Access Compliance Report

Public Rights-of-Way

Intersection ID: 8305	Main Street: FREEDOM_DR	Cross Street: PARK_FAIRFAX_DR	Location: SE
ADA ID: 6486F56D81AD	Ramp Type: PerpDiag	Initial Pass/Fail: Pass	Overall Compliance: No
		Severity Score: 0.25

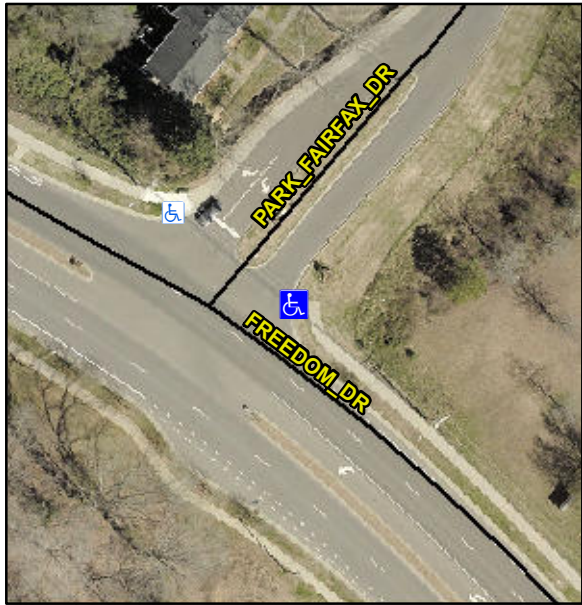
Codes/Mitigation Info/Possible Solution			Field Measurements/Component Compliance					
	Possible Solutions:		Compliance	Description	Data	Compliance	Description	Data
	Remove & Replace Curb Ramp With Two New Directional Ramps or Equivalent. Remove & Replace Gutter.		N/A	Ramp Length (in)	84.0	Yes	Ramp Slope (%)	7.0
			Yes	Ramp Width (in)	48.0	No	Ramp XSlope (%)	4.4
			N/A	Flare Type LT	Sloped	N/A	Flare Type RT	N/A
			N/A	Flare Slope LT (%)	6.2	N/A	Flare Slope RT (%)	6.0
			N/A	Flare Traversable LT?	No	N/A	Flare Traversable RT?	No
			Yes	Landing Length (in)	71.0	Yes	DWS Provided?	Yes
			Yes	Landing Width (in)	50.0	Yes	DWS Contrast?	Yes
			Yes	Landing Slope (%)	1.7	Yes	DWS Length (in)	24.0
			No	Landing X Slope (%)	2.1	Yes	DWS Full Width?	Yes
Surveyor Notes:		N/A	N/A	Landing Curb? (Y/N)	No	Yes	DWS Offset (in)	1.8
PROW/ADA:		R304.5.3	N/A	Shared Landing?	No			
			Yes	Gutter Ponding?	No	Yes	Gutter Slope (%)	2.4

Yes	Gutter Lip Ht (in)	0.0	No	Gutter X Slope (%)	2.3
			N/A	Painted X Walk1?	No	N/A	Painted X Walk2?	No
				X Walk 1 Direction	To NW		X Walk 2 Direction	To SW
			N/A	X Walk 1 Width (in)	N/A	N/A	X Walk 2 Width (in)	N/A
				X Walk 1 Slope (%)	4.6		X Walk 2 Slope (%)	1.7
				X Walk 1 X Slope (%)	2.5		X Walk 2 X Slope (%)	3.3
			N/A	Ramp inside XWalk1?	N/A	N/A	Ramp inside XWalk2?	N/A
				Road Slope (%)	1.0	N/A	Clear Space?	Yes
				Road X Slope (%)	4.8	N/A	Clear Space to XWalk (in)	31.5
			Yes	Any Obstructions?	No	Yes	Storm Grate/Utility Hazard?	No
				Obstruction Type			Storm Grate/Utility Type	
					N/A			N/A
						Yes	Surface Condition? (G/P)	Good
